Patio Home with Upper Level

The following items are conditions for permit issuance and strict compliance is mandatory.

- 60. REQUIREMENTS FOR ALL STAIRS: MSBC1309/R311.7-R311.7.8.4

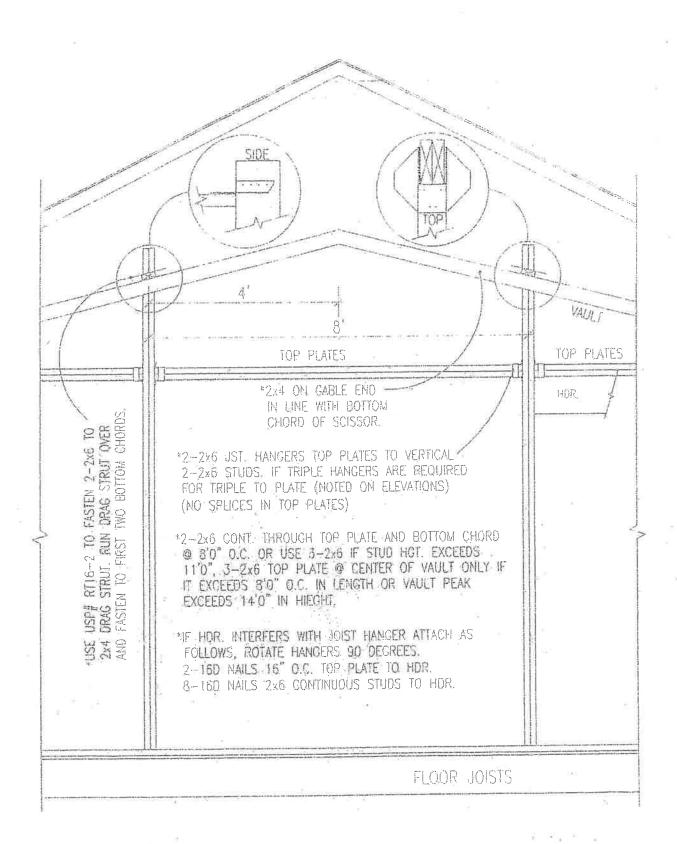
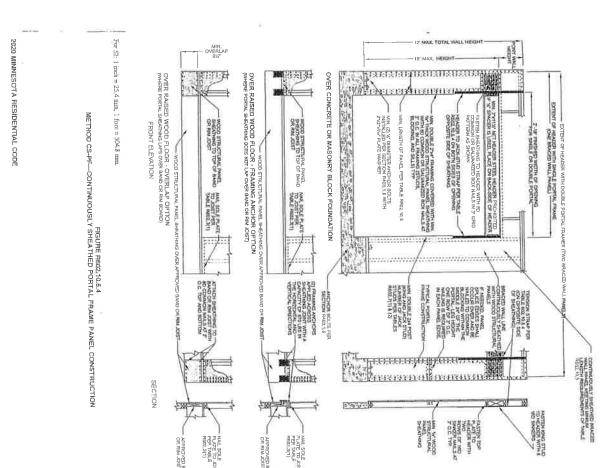
1. 36" minimum width

6. 7¾" maximum rise

2. 10" minimum tread

7. Minimum of 6'8" headroom

- 3. Use 3 2 x 12 stringers 8
- 8. Use Joist Hangers
- 4. Double joist around openings
- 5. 34"-38" high continuous gripable handrail with ends returned to wall.

Open risers are permitted, provided that the opening between treads does not permit the passage of a four inch (4") diameter sphere.

The greatest riser height and tread depth within any flight of stairs shall not exceed the smallest by more than 3/8 inch.

Guards on stairs shall not be less than 34" in height measured vertically from the nosing of the treads. MSBC1309/R312.1.2 exception #1

Nothing four and three-eighth inches (4-3/8") or more in diameter shall pass through the guards (on stairways). MSBC1309/R312.1.3

FIGURE R602.10.6.4
METHOD CS-PF—CONTINUOUSLY SHEATHED PORTAL FRAME PANEL CONSTRUCTION

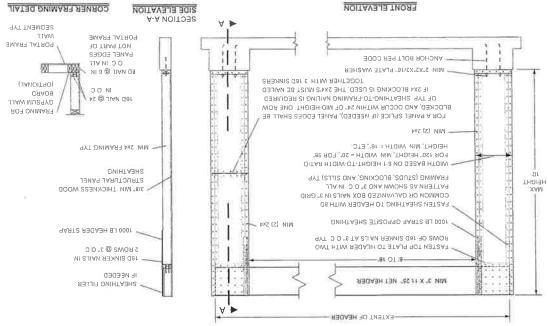
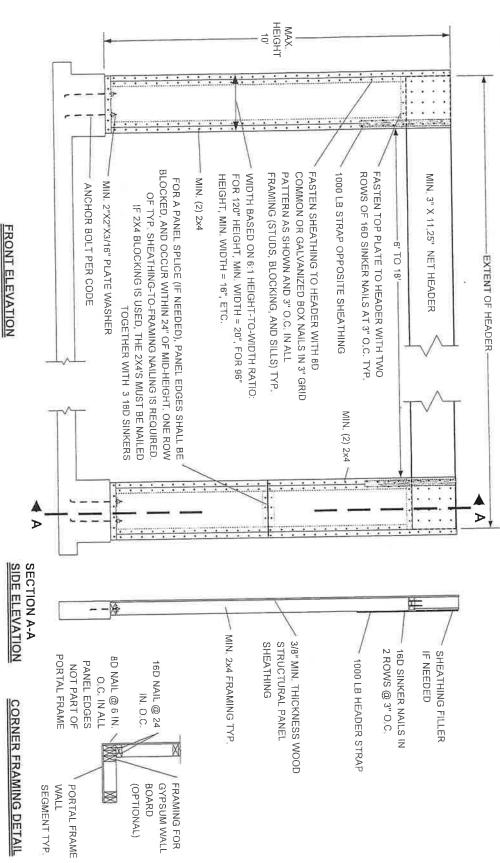
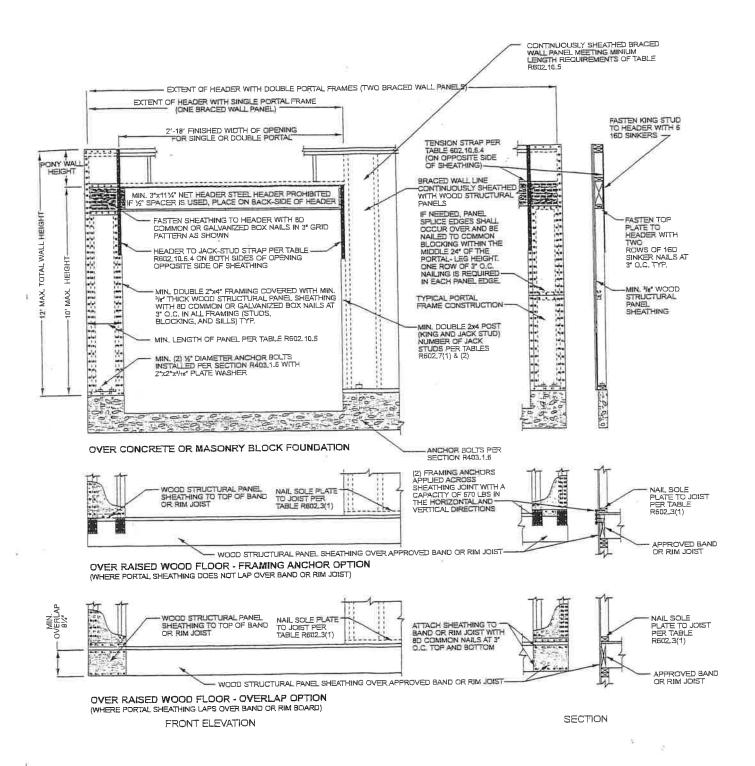
- 14. Wall section on the front of the garage less than 2'-8" wide shall be braced wall panels.(see attached) MSBC1309/R602.10
- 15. Approved numbers or addresses shall be provided for all new buildings in such a position as to be plainly visible and legible from the street or road fronting the property. MSBC1309/R319.1
